# MSEX2022A-03

## S E R V I C E N O T E

MSEX2022A – Oscilloscope, Mixed Signal, 2+8 Channel,  
200MHz

**With the oscilloscope’s power on and while under normal operation the unit emits a hissing noise.**

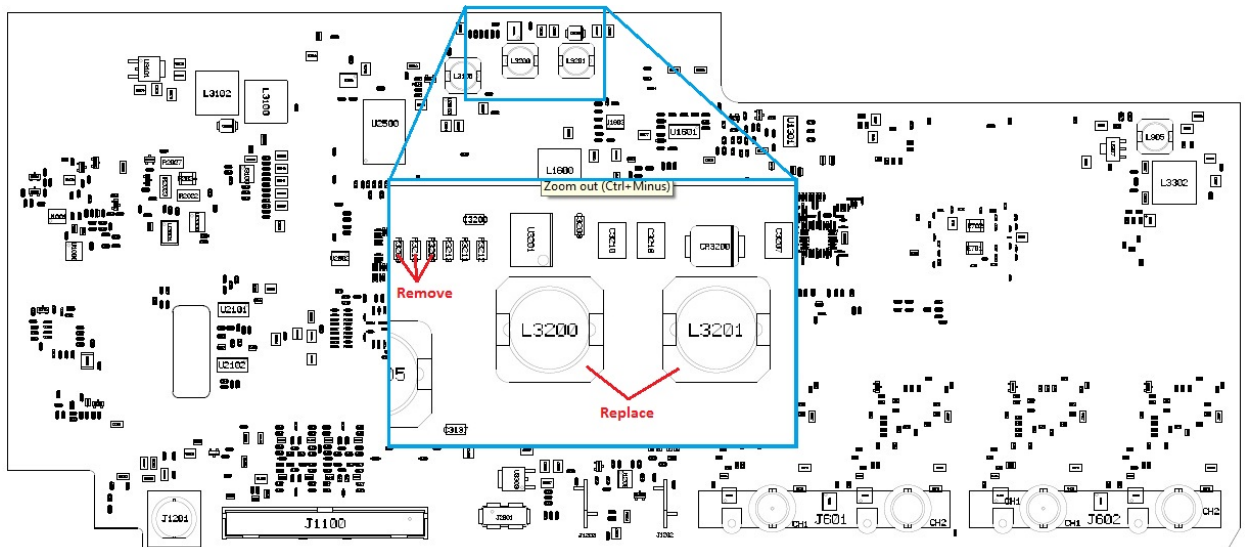
With the oscilloscope power turned on and while under normal operation, the unit emits a hissing noise.

2. As the picture indicates, remove the three resistors (0699-7209, 1 Ohm) located at R3208, R3209, and R3210. They are not to be replaced.
3. Remove as well the two inductors (9140-6474, 100uH) located at L3200 and L3201 and replace them with inductors with part number 9140-6151 (68 uH).
4. Re-assemble to the point where the unit could be powered up to verify that the hissing is indeed gone. If the hissing is not gone, please, check modifications.
5. When the hissing is gone, put oscilloscope back together.
